re: Geotechnical Review - Frost Protection for Footings
Proposed Commercial Development - Building A
2165 Robertson Road - Bells Corners - Ottawa, Ontario

date: July 26, 2021
file: PG4694-MEMO.03

PG4694-MEMO.03 - Geotechnical Recommendations - Frost Protection for Footings - Building A

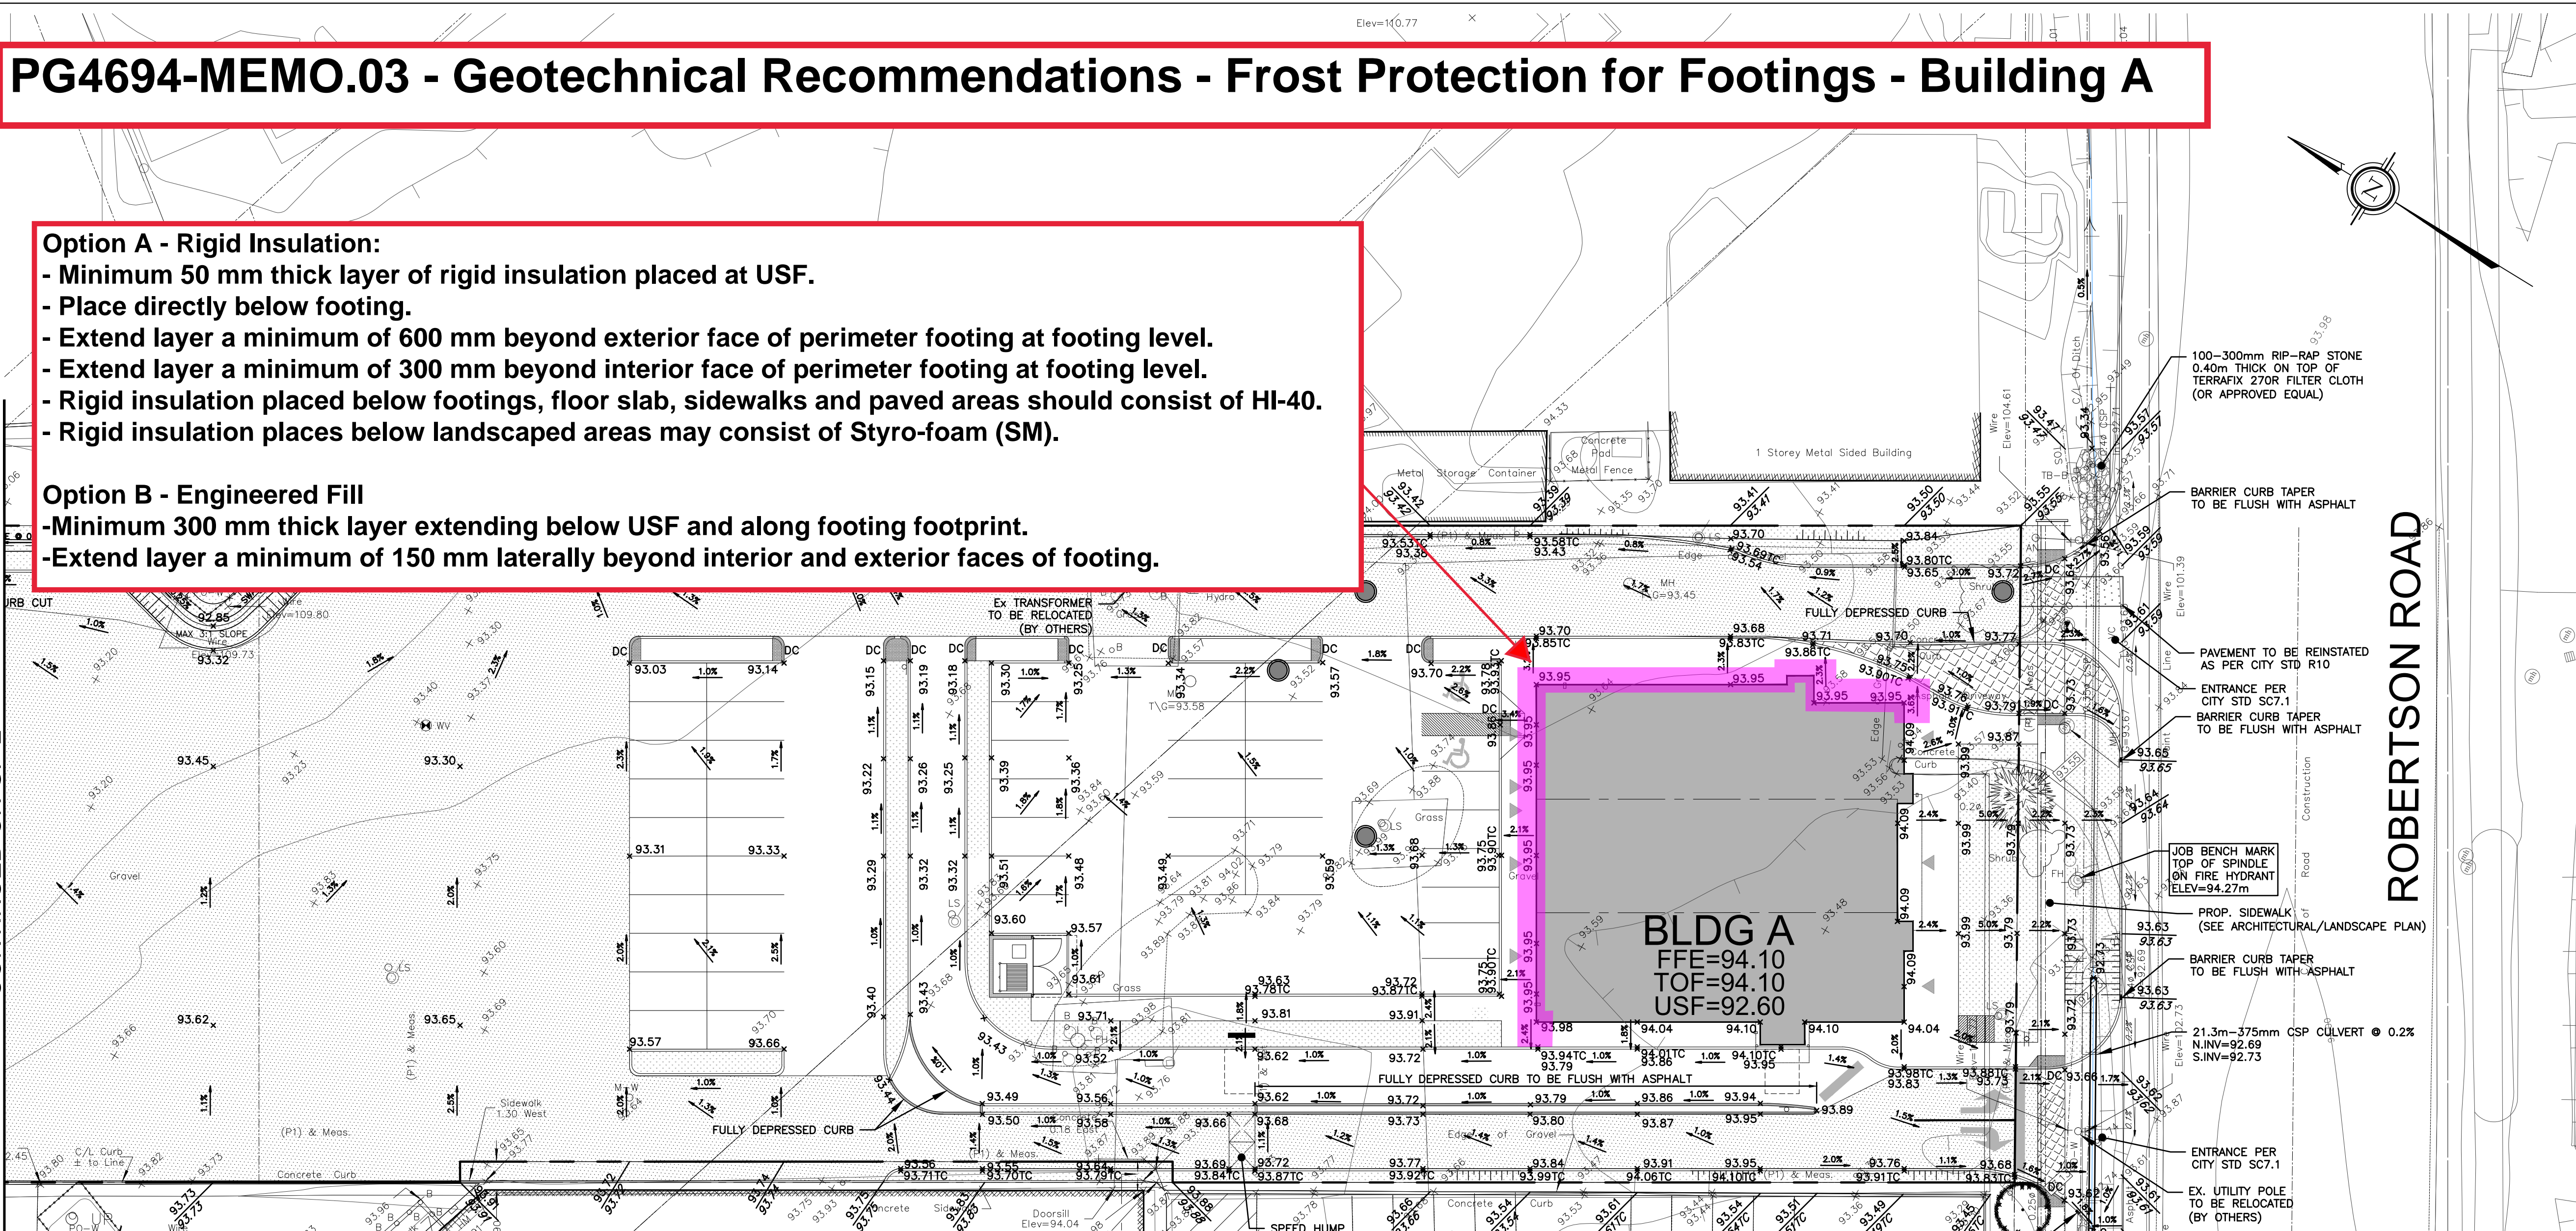
Based on our review, the north and eastern portion of the proposed building was noted to be provided reduced soil cover for footings of heated structures against frost action.

Option A - Rigid Insulation:

- Minimum 50 mm thick layer of rigid insulation placed at USF.
- Place directly below footing.
- Extend layer a minimum of 600 mm beyond exterior face of perimeter footing at footing level.
- Extend layer a minimum of 300 mm beyond interior face of perimeter footing at footing level.
- Rigid insulation placed below footings, floor slab, sidewalks and paved areas should consist of HI-40.
- Rigid insulation places below landscaped areas may consist of Styro-foam (SM).

Option B - Engineered Fill

- Minimum 300 mm thick layer extending below USF and along footing footprint.
- Extend layer a minimum of 150 mm laterally beyond interior and exterior faces of footing.
